## THM 4T60-E NEW DESIGN 1-2 ROLLER CLUTCH

**CHANGE:** Beginning at the start of production for 1996 models, all THM 4T60-E transaxles were built with a new design 1-2 Roller Clutch Assembly, as shown in Figure 1.

Figure 1

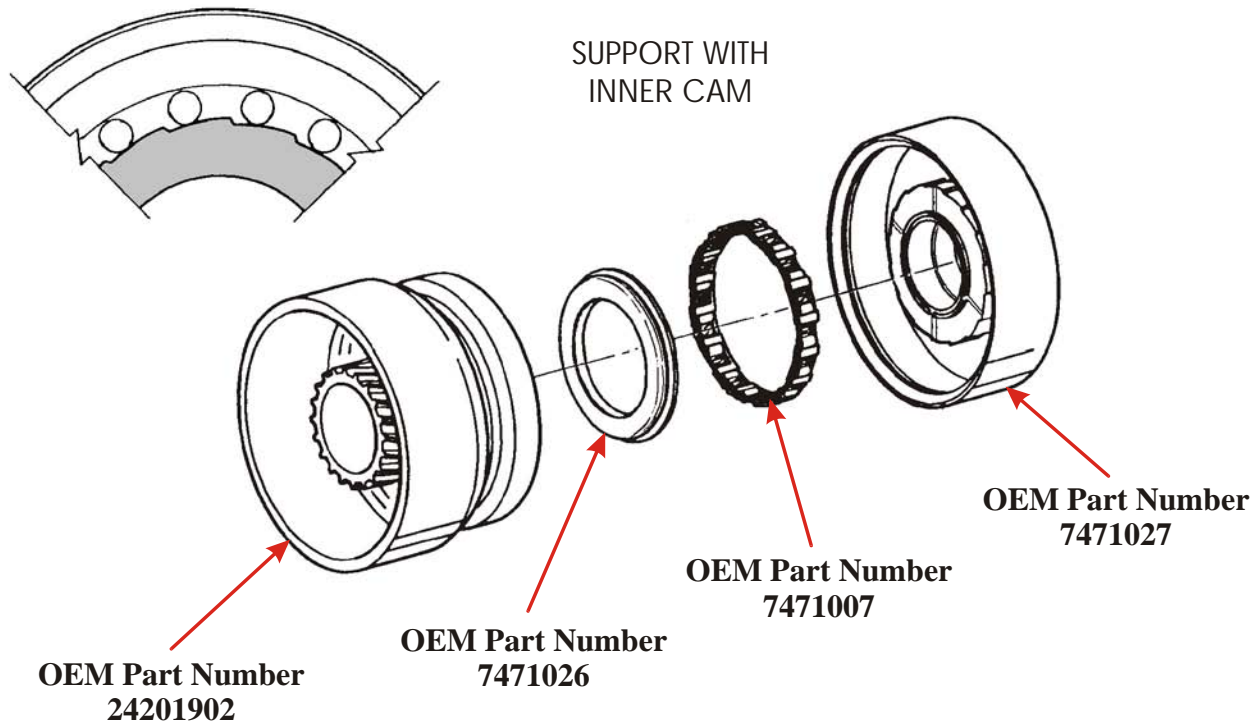
**REASON:** Eliminates a potential high speed freewheel failure and reduces the number of parts needed for the assembly process.

- (1) 1-2 ROLLER CLUTCH SUPPORT - Roller clutch cam is now the inside diameter design instead of the previous outside diameter design, and the bushing that supports it on the final drive ring gear has doubled in width for much improved stability of the 1-2 Roller Clutch Support. Refer to Figure 1 for illustrations.

- (2) THRUST BEARING - Dimensional changes to accommodate the new design 1-2 roller clutch support (See Figure 1).
- (3) 1-2 SUPPORT SPACER - Eliminated, as shown in Figure 1.

- (4) 1-2 ROLLER CLUTCH ASSEMBLY - Dimensional changes to accommodate the new inside diameter cam design 1-2 roller clutch parts, as shown in Figure 1.

- (5) 1-2 ROLLER CLUTCH SNAP RING - Eliminated, as shown in Figure 1.
- (6) 1-2 ROLLER CLUTCH INNER RACE - Eliminated, as shown in Figure 1.
- (7) REACTION SUN GEAR DRUM - Redesigned with the 1-2 roller clutch outer race now made as part of the sun gear drum, to accommodate the new design 1-2 roller clutch parts, as shown in Figure 1.

Figure 2

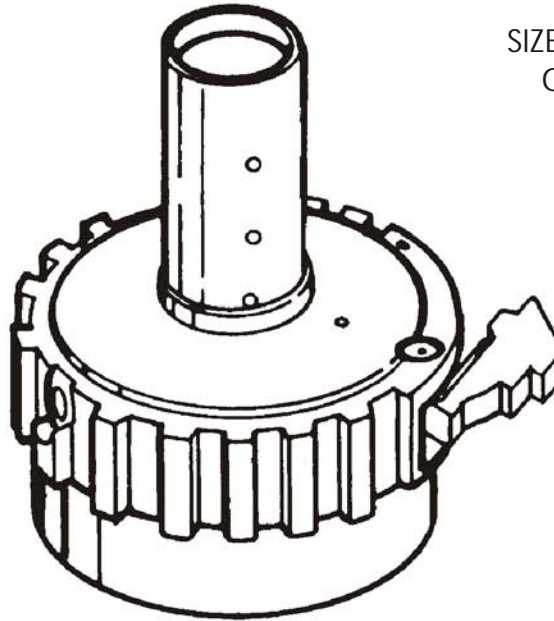
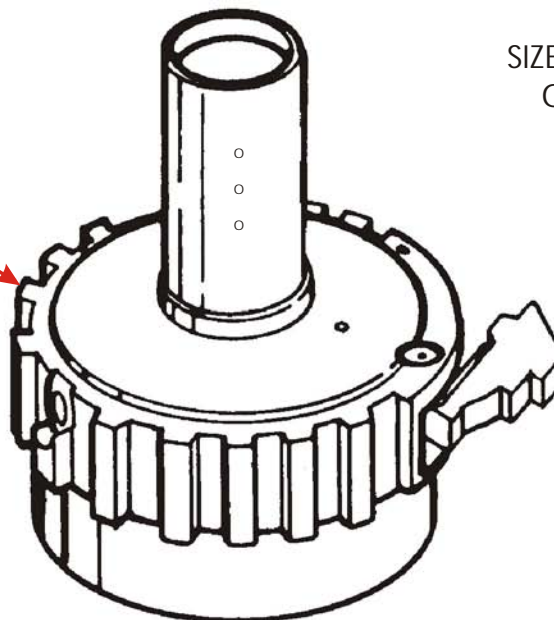
- (8) FINAL DRIVE RING GEAR - Revised lubrication hole sizes and locations in support to accommodate the new design 1-2 roller clutch assembly, as shown in Figure 2.
